Addendum No. 2

**CITY OF ABERDEEN
ABERDEEN, MARYLAND
DEPARTMENT OF PUBLIC WORKS
ABERDEEN ADVANCED WWTP HEAT
EXCHANGER REPLACEMENT**

Engineering Project No. 11205021

Client	CITY OF ABERDEEN		
Project	ABERDEEN AWWTP HEAT EXCHANGER REPLACEMENT		
Title	EXISTING ADMINISTRATION & SOLIDS BUILDING HEATER ROOM PLAN		
Project No.	11205021		
Original Size	Arch D	Sheet No.	D-101
		Sheet	8 of 16

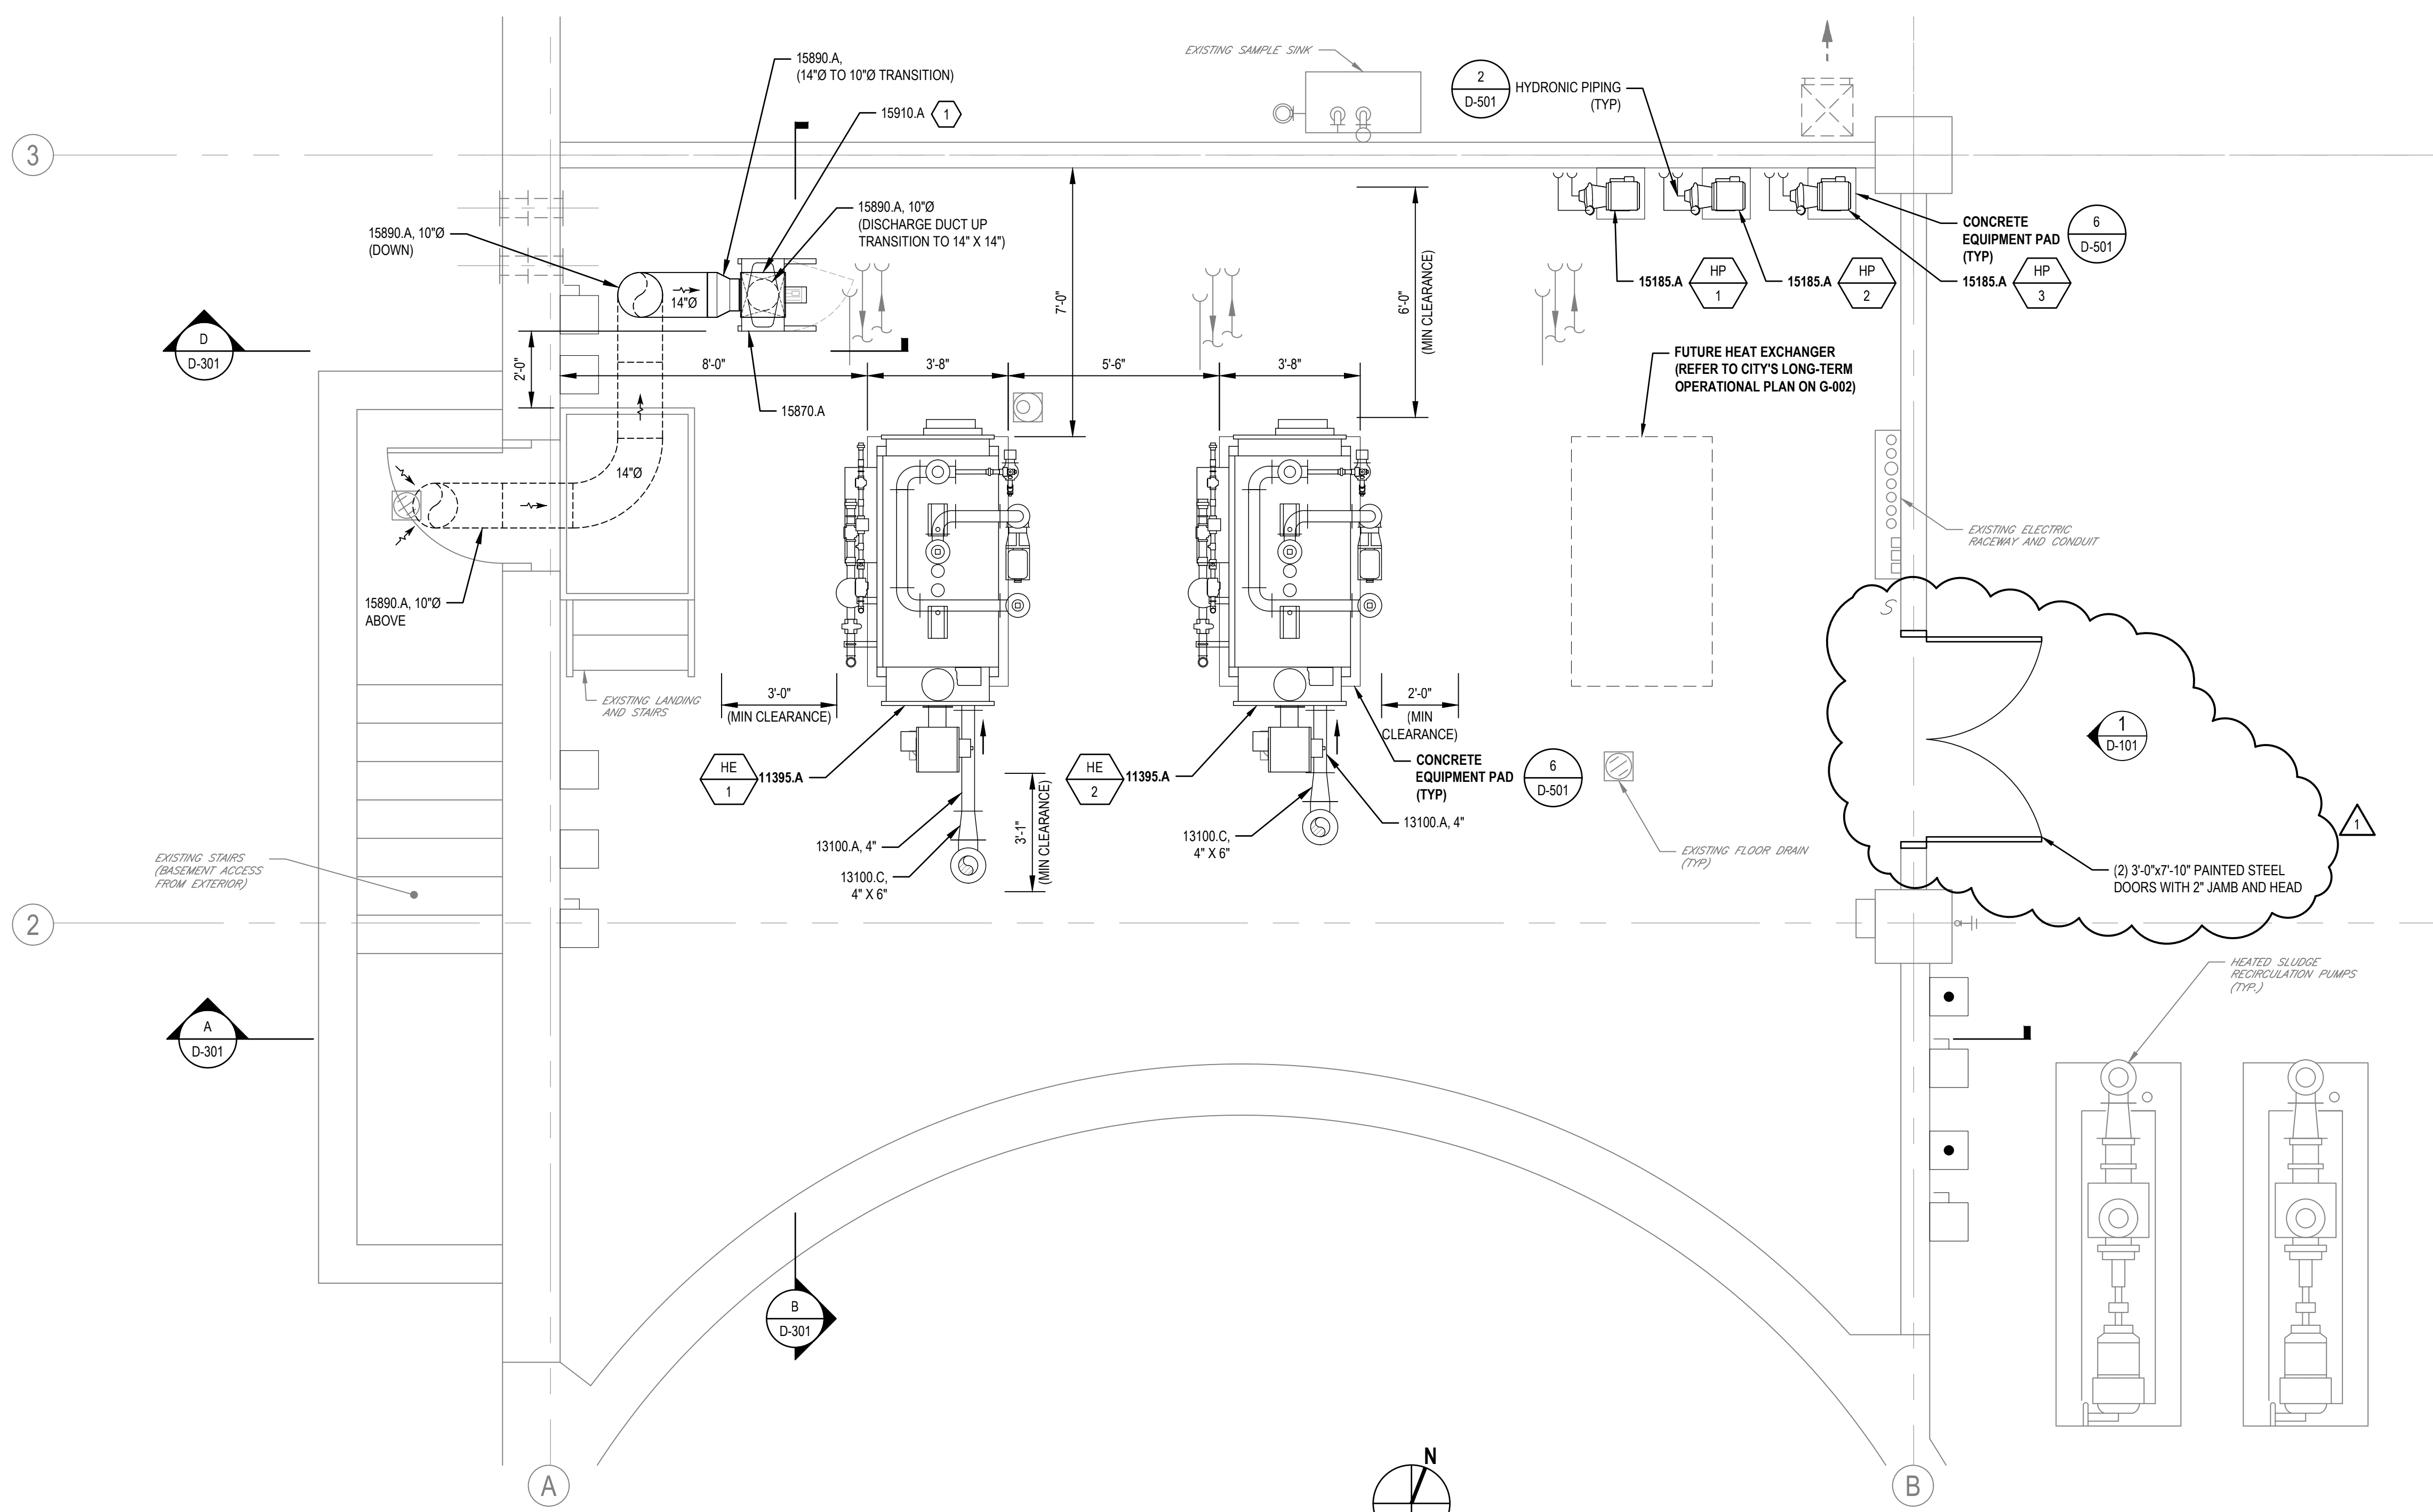
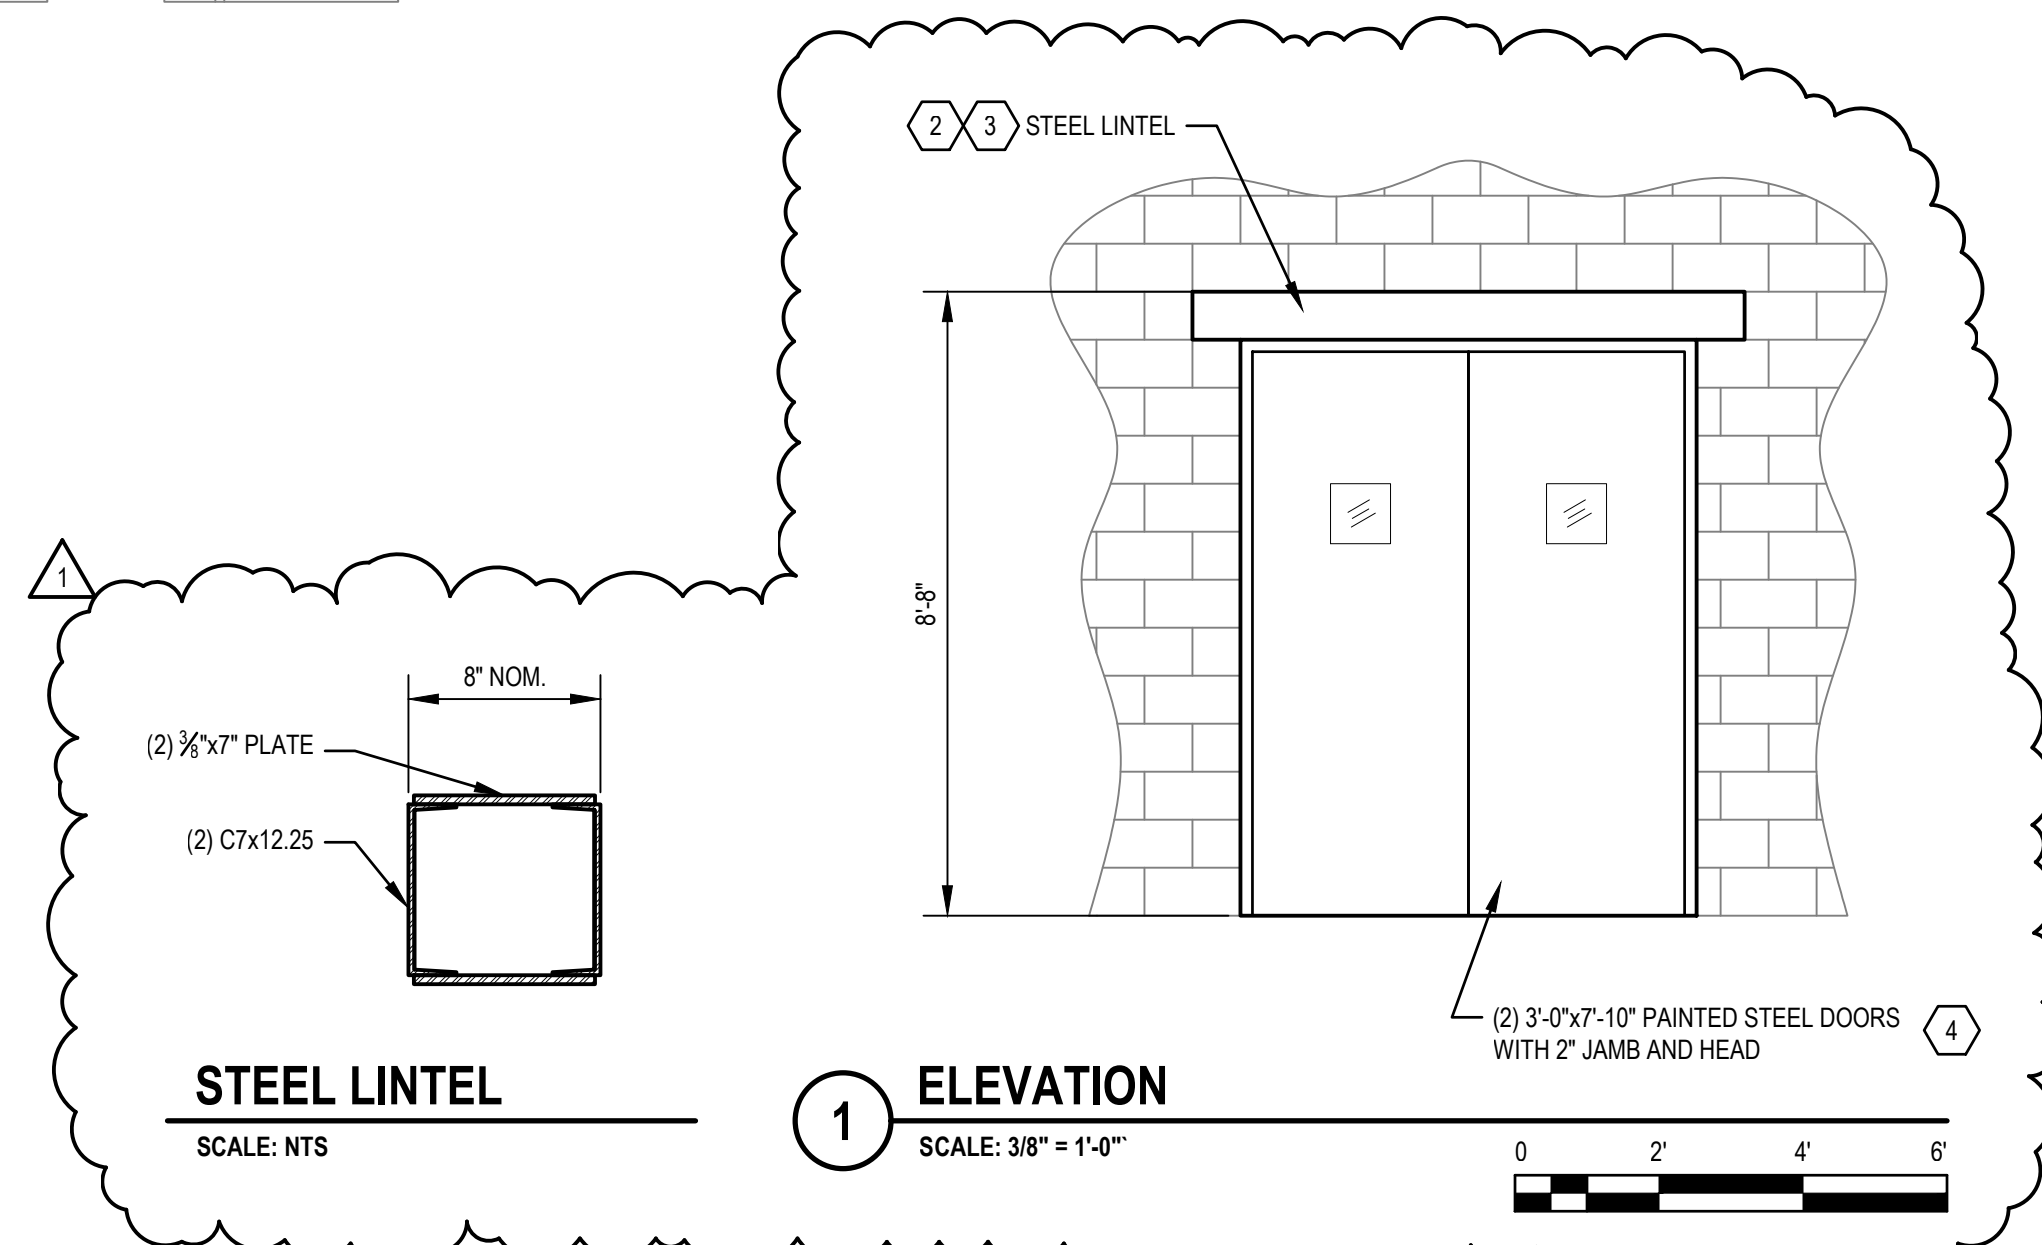
4. The existing Heater Room door is to be replaced with a new double door (see attached specification and drawing).
5. A codes review of the Heater Room has identified the designation as "Unclassified". Based on this codes review, explosion proof fixtures are not required.

1. **REPLACE** Drawing D-101 with the attached sheet.

- CONTRACTOR TO PROVIDE WIRE MESH SCREEN AT COMBUSTION AIR OUTLET.
- SAW CUT MASONRY. TOOTH VERTICAL EDGE AT NEW LINTEL LOCATION.
- PROVIDE LINTEL FOR NEW DOOR OPENING. LINTEL TO BEAR 8" MINIMUM ON EACH SIDE OF OPENING. REPAIR AFFECTED MASONRY. REPAIR AND PAINT BOTH SIDES OF WALL.
- COORDINATE OPENING REQUIREMENTS FOR DOORS WITH APPROVED MANUFACTURER'S SHOP DRAWINGS.
